P11-0899 (AT&T) Iron Horse Trail

Memorandum

To: Jenny Soo, City of Pleasanton Jonathan L. Kramer From: €sq.,// June 27, 2013 Date: RE: P11-0899 2126 Rheem Dr. (AT&T Wireless)

Figure 2: Partial bark cladding (Photo by J. Kramer).

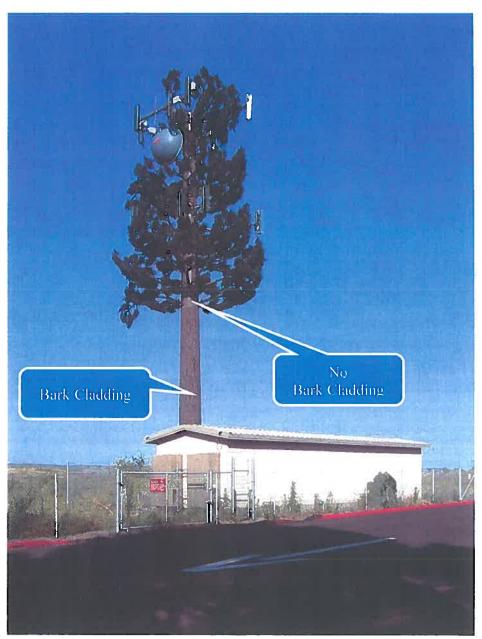
Figure 2, below, illustrates the visual discontinuity and heightened sun reflections from the flat surfaces that lack three dimensional bark cladding.

The planned design does not show that the monopine will use bark cladding from top to bottom and on all branches. I recommend that full length bark cladding be a City requirement.
